Direction de la sûreté
des installations
nucléaires

DSIN-FAR/SD6/N° 01-60 119

Following a DSIN's request, the Institute for Nuclear Safety and Protection has initiated a comparative technical evaluation of several advanced nuclear power plant projects with the objective to notably identify relevant advantages with regard to safety.

ANNEX

2-Rupture risk of the Component Cooling Water System (CCWS) outside containment due to thermal barrier RCP rupture

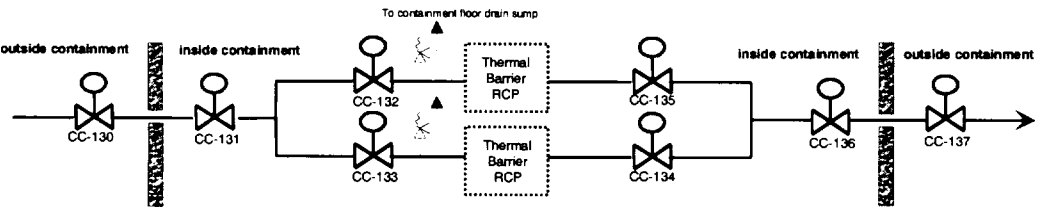
How is designed the piping section between valves CC-132-135 and CC-133-134? To the reactor coolant pressure and temperature? Which criteria is used to close those valves (pressure, flow rate...)? How are designed the flow meter in those sections?

The containment isolation valves (CC-130, 131, 136, 137) are automatically closed on low-low CCW surge tank. In case of overpressure and non-functionality of the previous relief valves (guillotine break), are the containment valves closed in the Control Room to assure isolation?

How do you assure that the leak flow meters keep their functionality when the primary coolant has two phases?
